CONTRACT 1725

**CIPP REHABILITATION OF THE
LOWER SAW MILL RUN INTERCEPTOR**

ADDENDUM NO. 3

Contract: 1725
 CAD File Name: 1725_MHPS_01.DGN
 Date: 5/28/2020
 Sheet: 29 OF 30

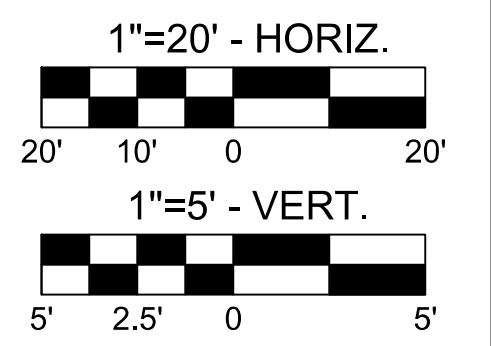
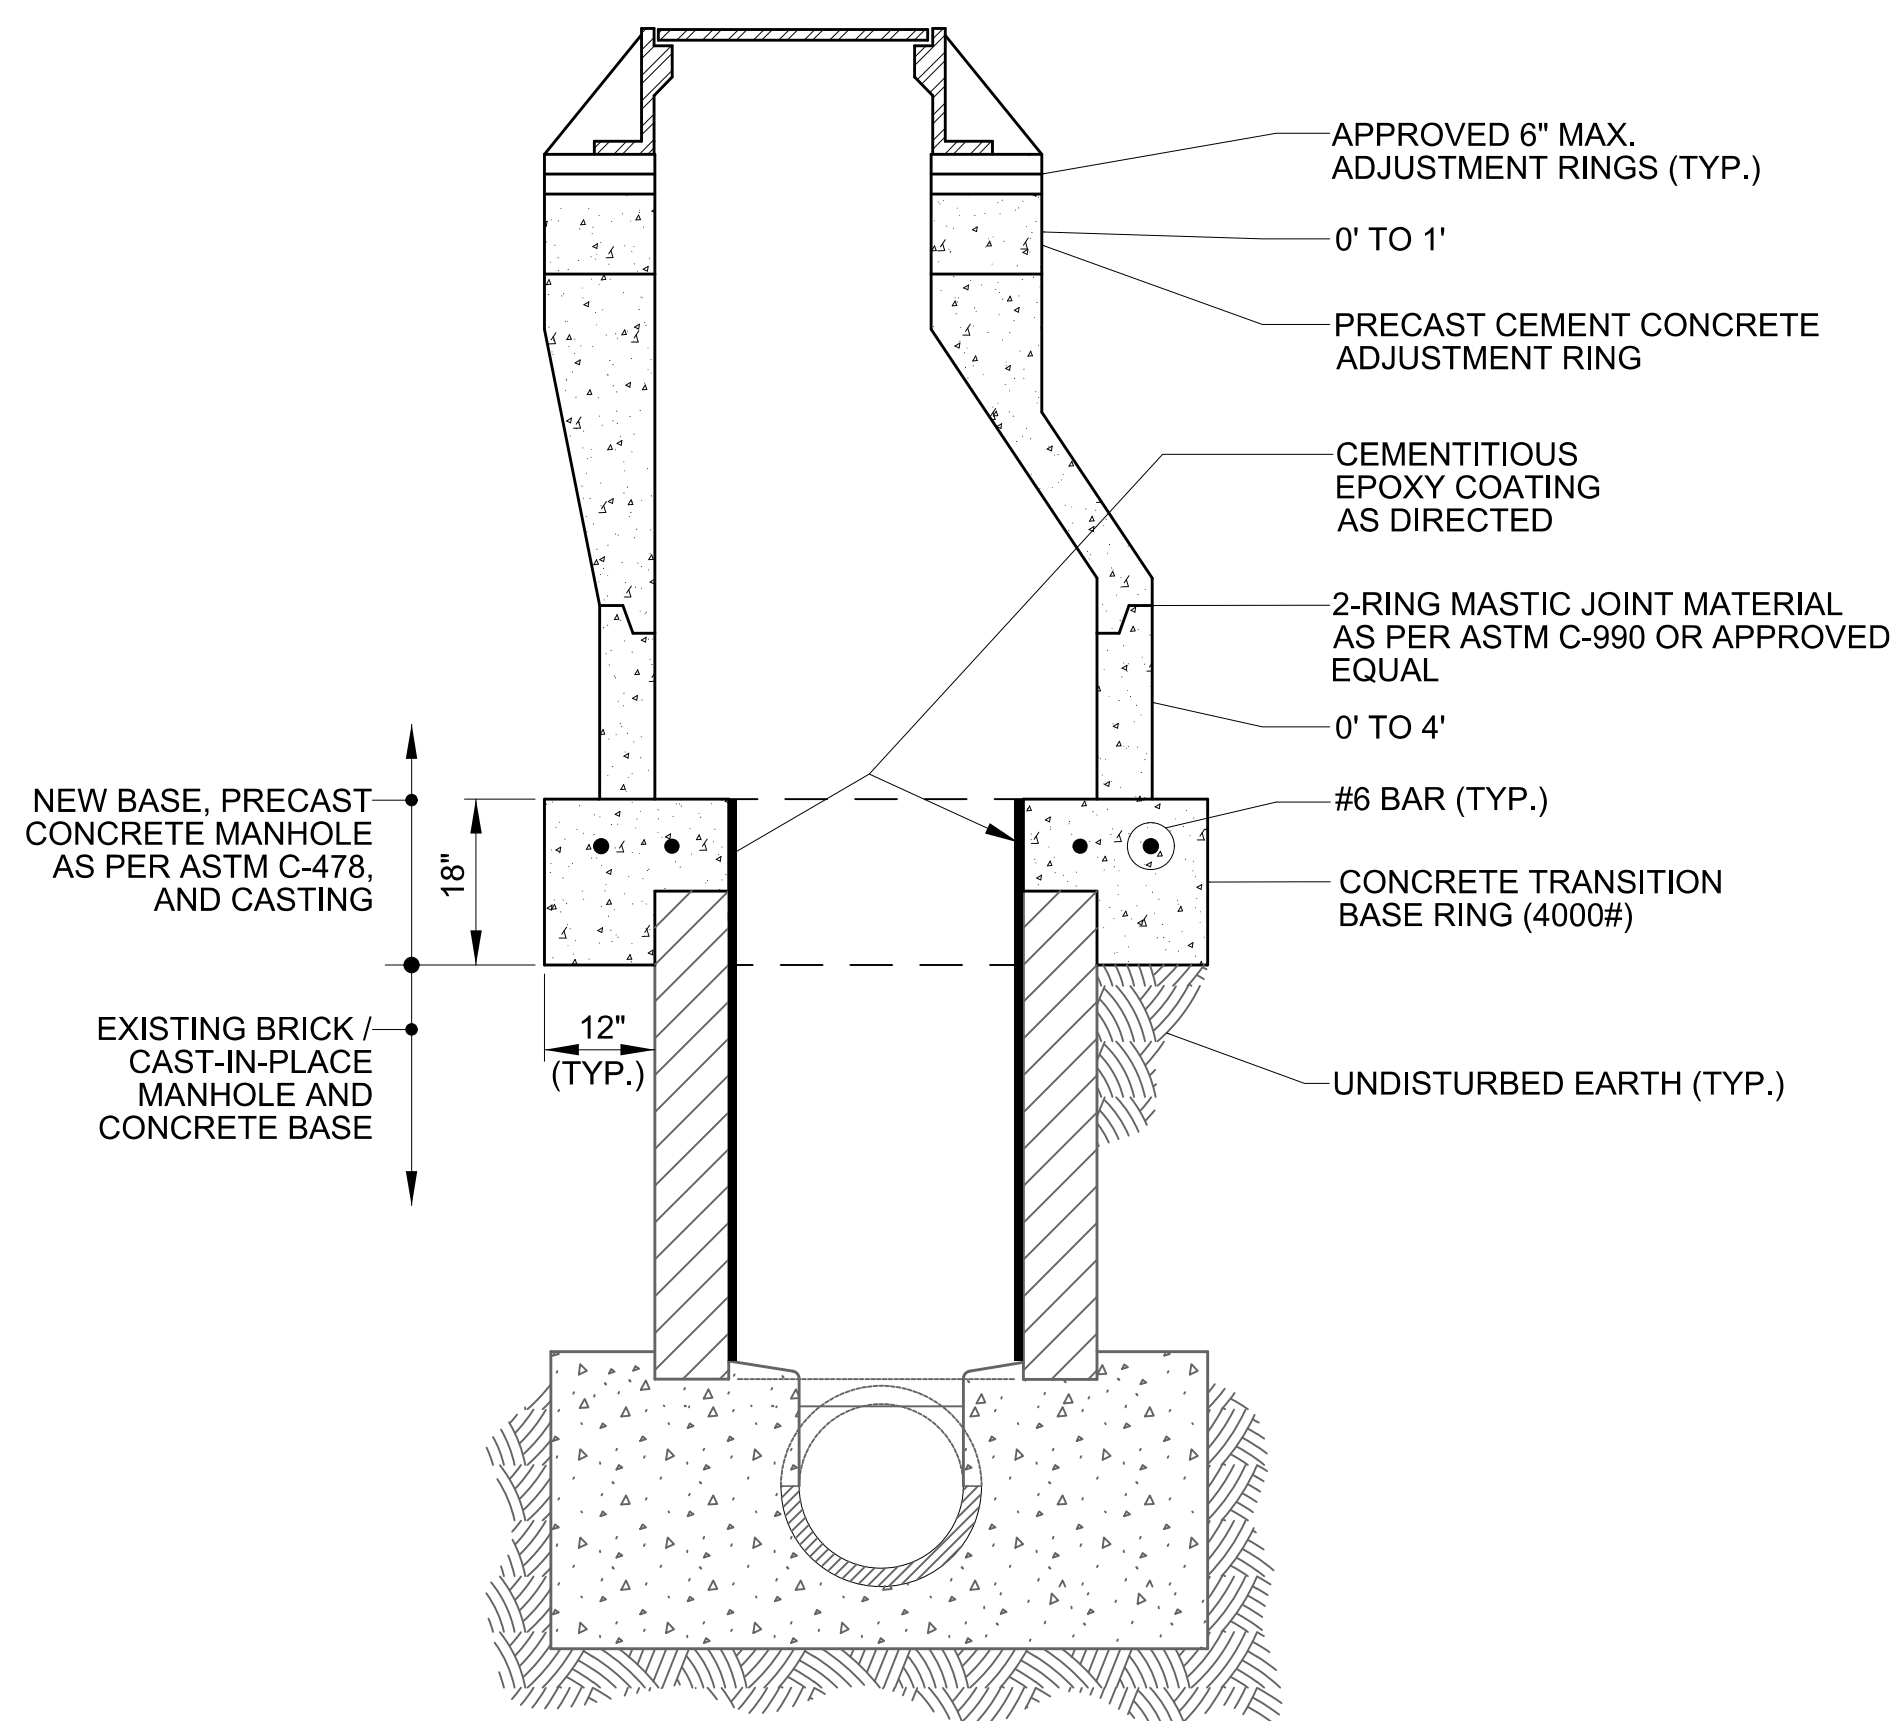
Sheet 29 of 30

Delete “BY OTHERS”

REVISION			
REV No.	DATE	DESCRIPTION	APPV
1	7/23/20	DELETE "BY OTHERS" PER ADDENDUM NO. 3.

NEW MANHOLE DETAIL 1

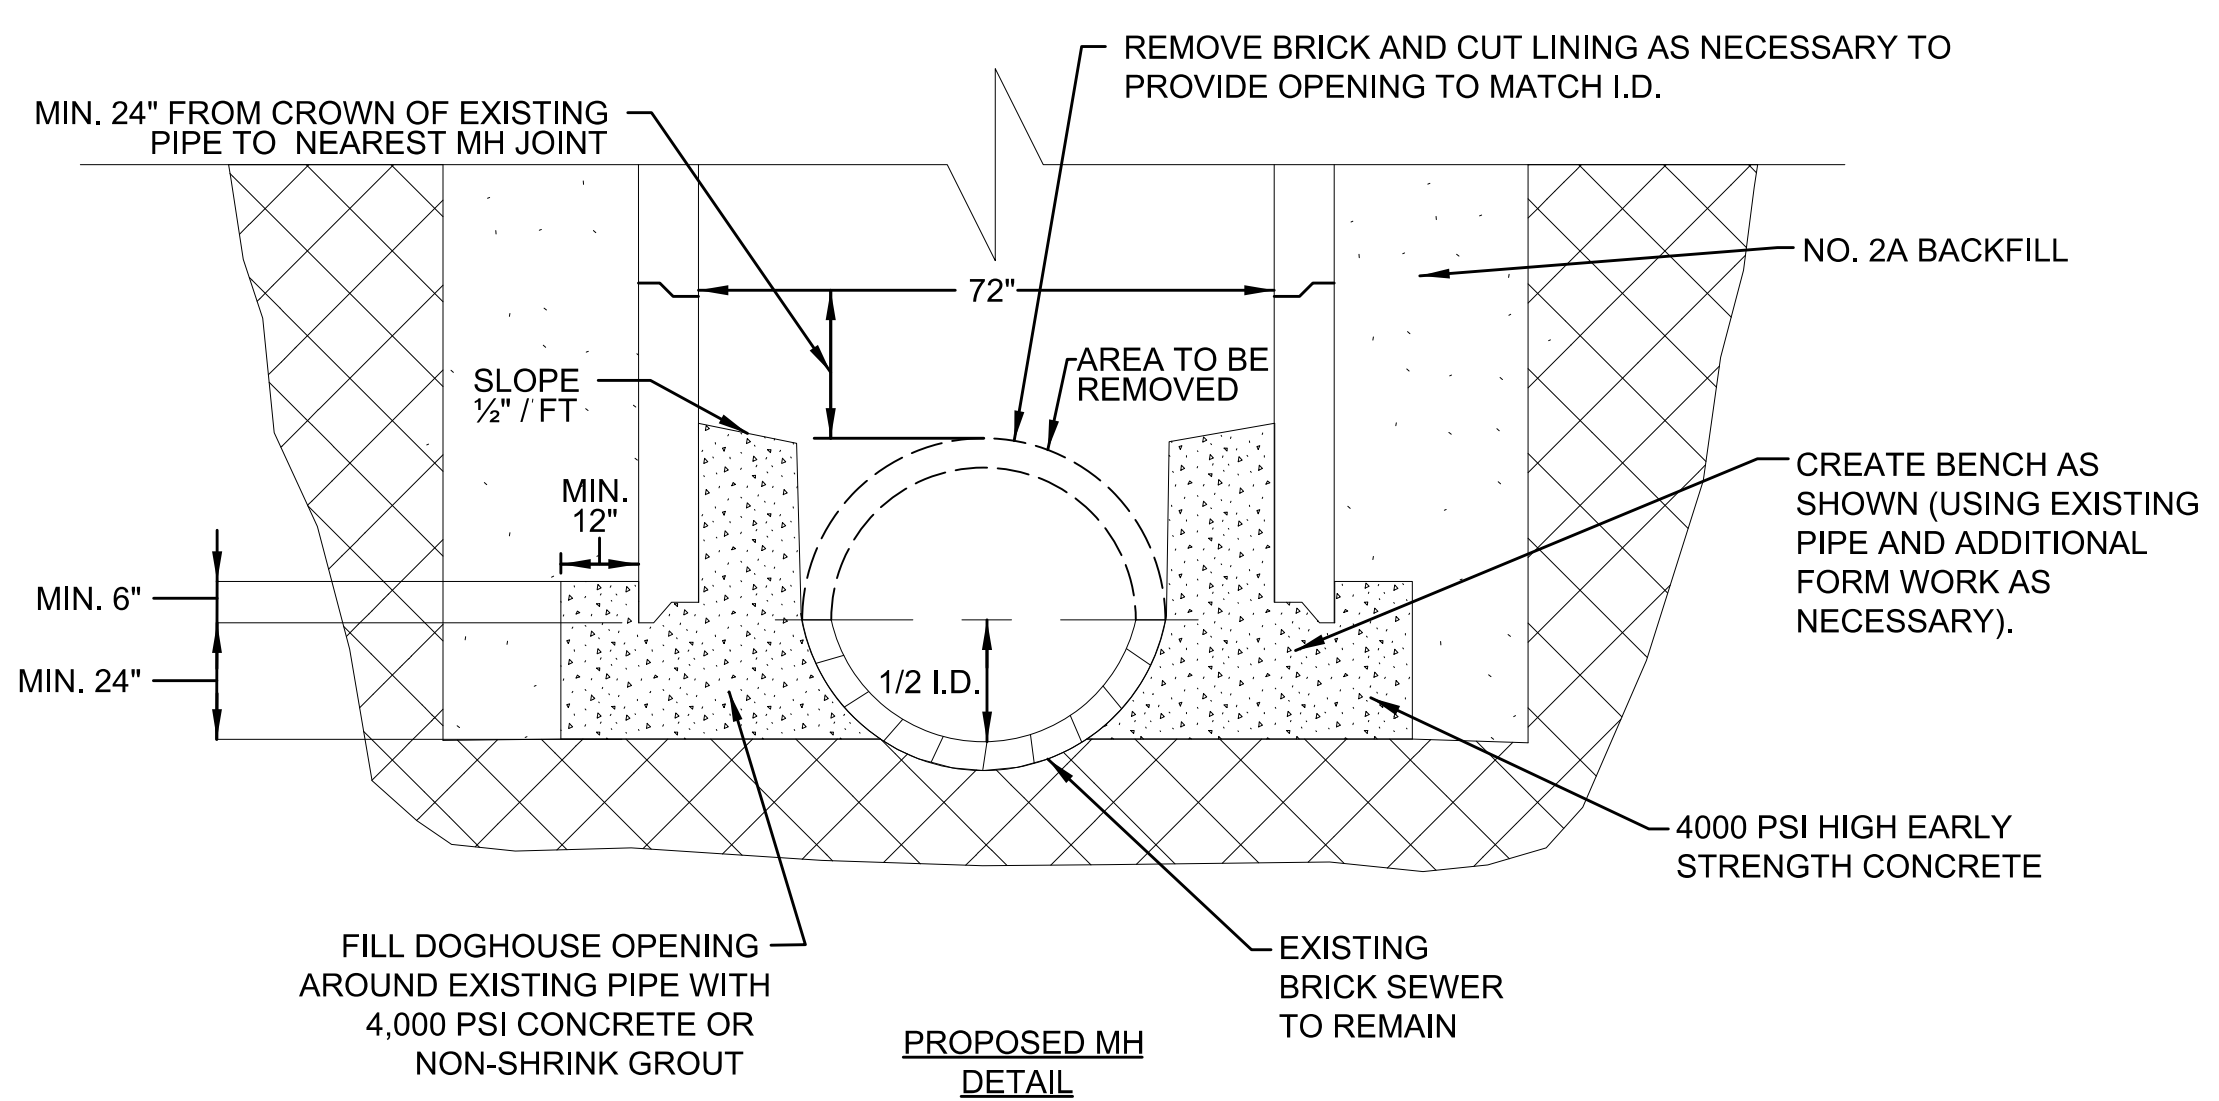
Sheet 30 of 30

Add NEW MANHOLE DETAIL 1 and NEW MANHOLE DETAIL 2.

REVISION			
REV No.	DATE	DESCRIPTION	APPV
1	7/16/20	ADD NEW MH DETAILS PER ADDENDUM NO. 3.
